Façade E

Façade F

view southeast- before

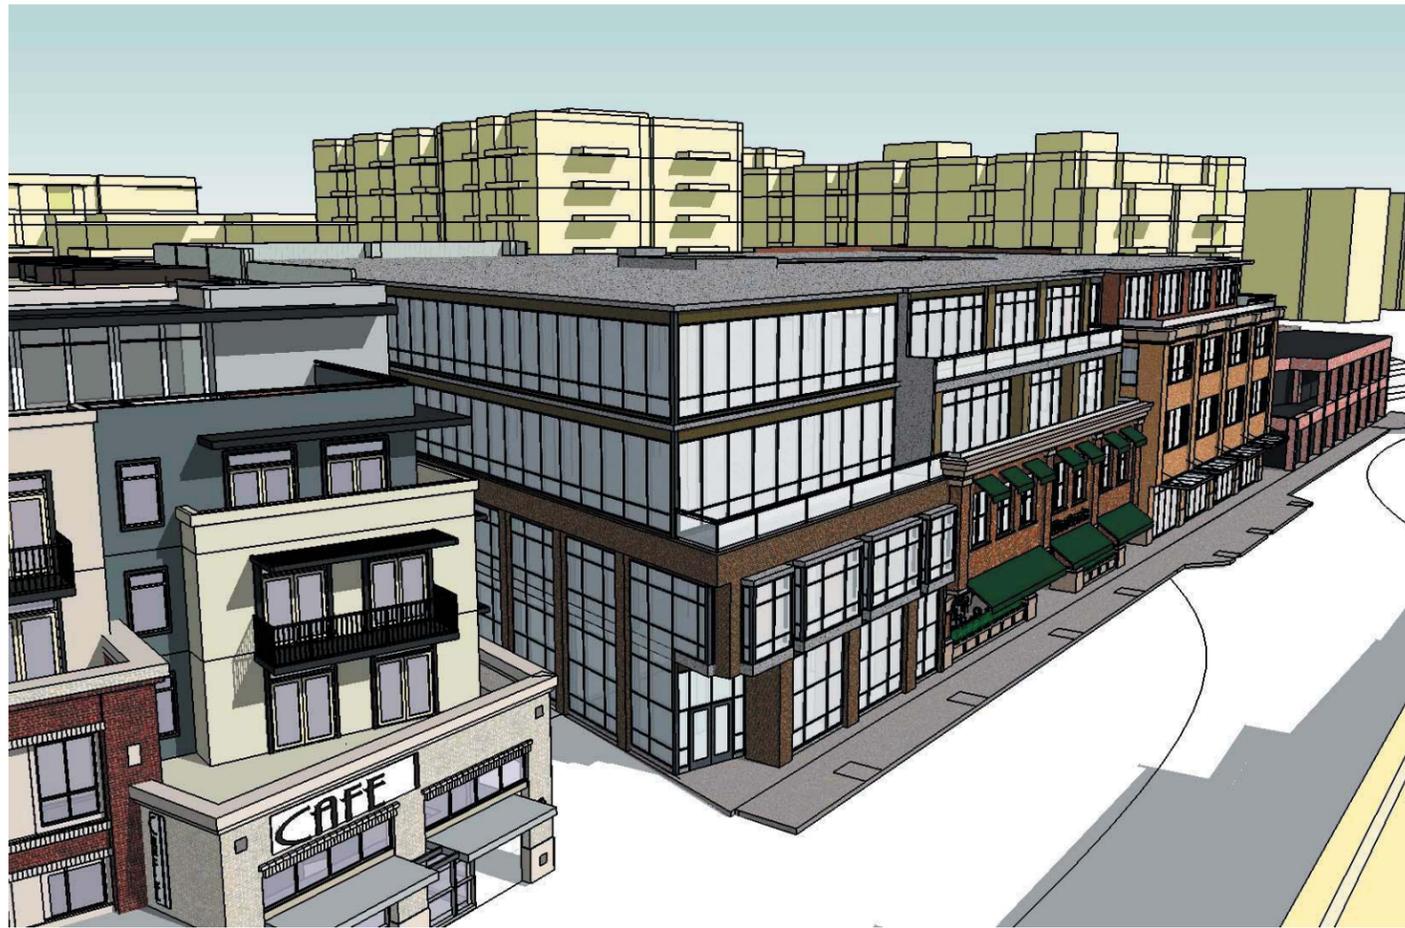
- 15 Pushed 3rd floor back to align with 4th floor
- 16 Added brick "Façade" at 1st and 2nd floors to frame opening to Pedestrian Meander and to "bring the upper levels to the ground"
- 17 Added canopy at level 2 floor
- 18 Created balcony at level 3 to overlook pedestrian meander
- 19 Changed materials on 3rd & 4th floor and created smaller building feel at SW corner
- 20 Re-oriented windows in 2 story vertical bands
- 21 Deleted ribbon windows and wrapped brick façade around the south west corner

aerial view looking northeast- before

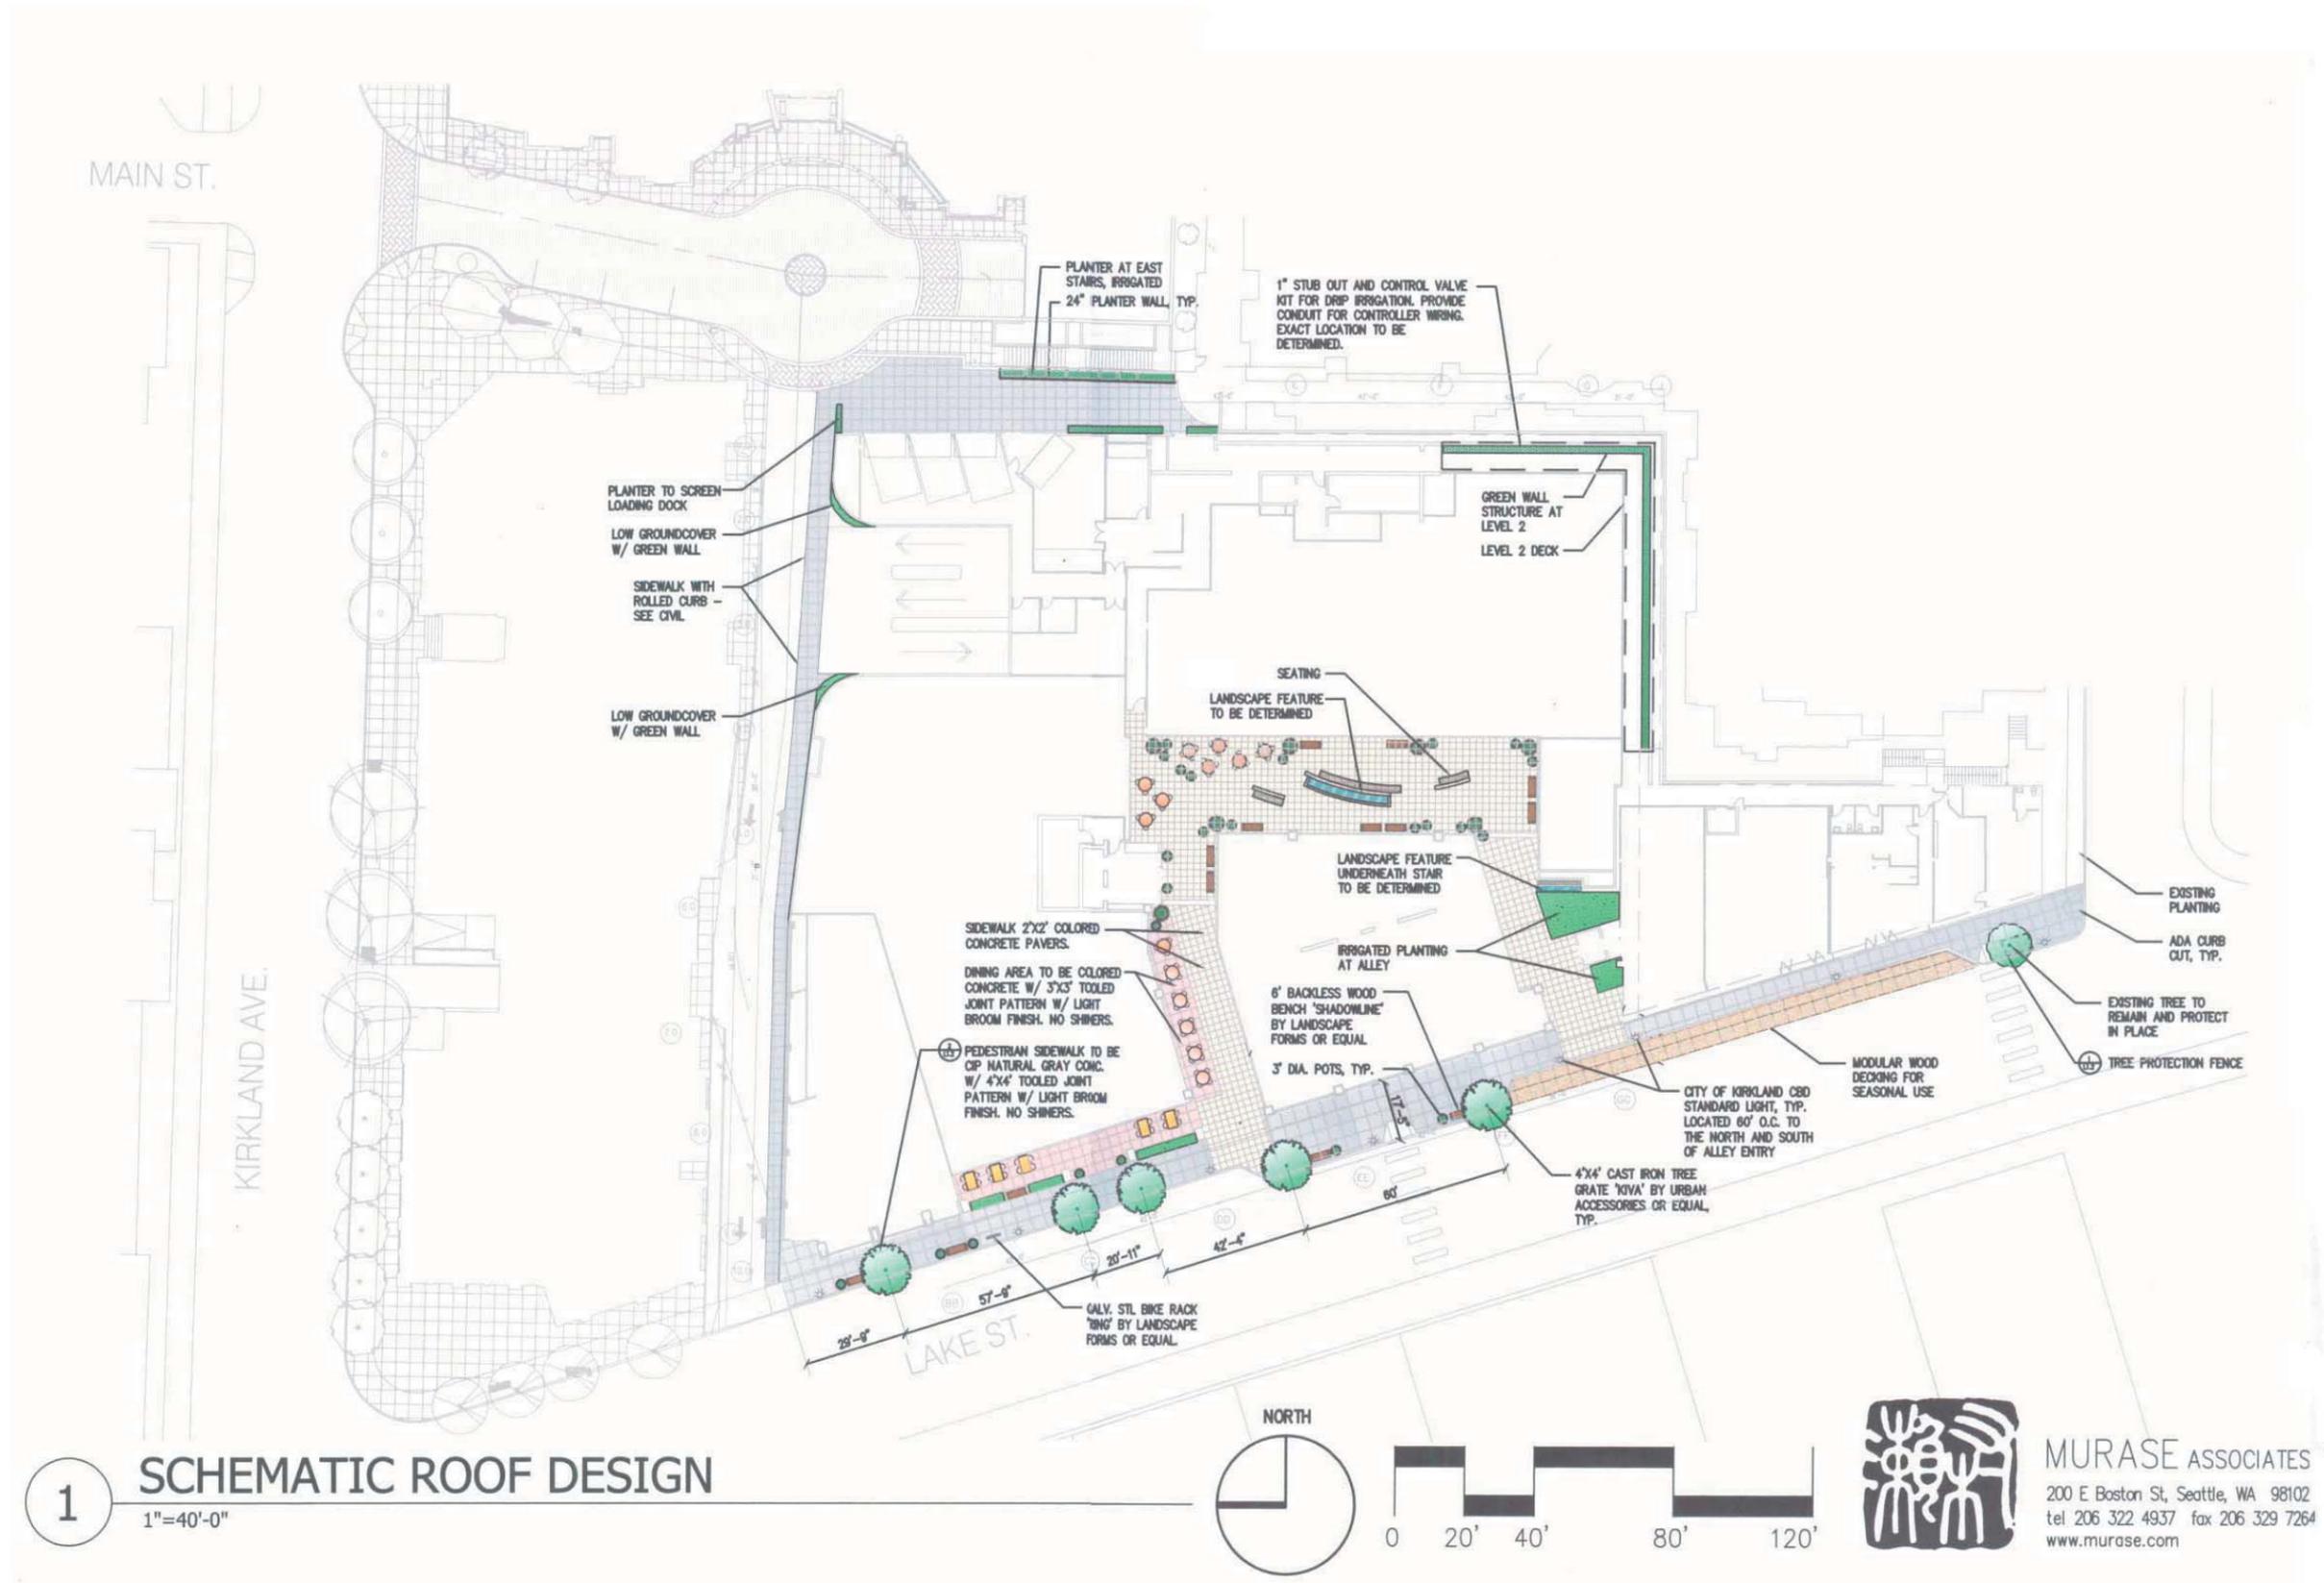
- 22 Completed brick frame at level 2 of existing Kirkland Waterfront Market building
